| Company | Trenz Electronic GmbH |
| PCN Number | PCN-20231006 |
| Title | TE0630-02 to TE0630-03 Hardware Revision Change |
| Subject | Hardware Revision Change |

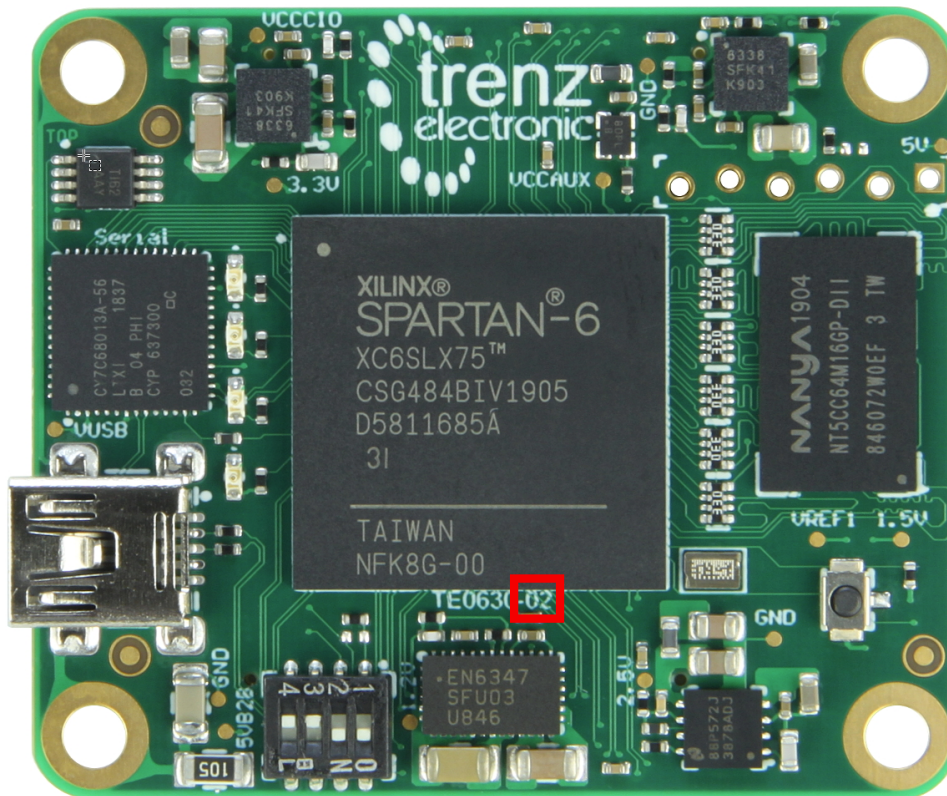
3 Method of Identification

The revision number is shown on the top side of the PCB. Revision number position changes between REV02 and REV03 on top side of the PCB.
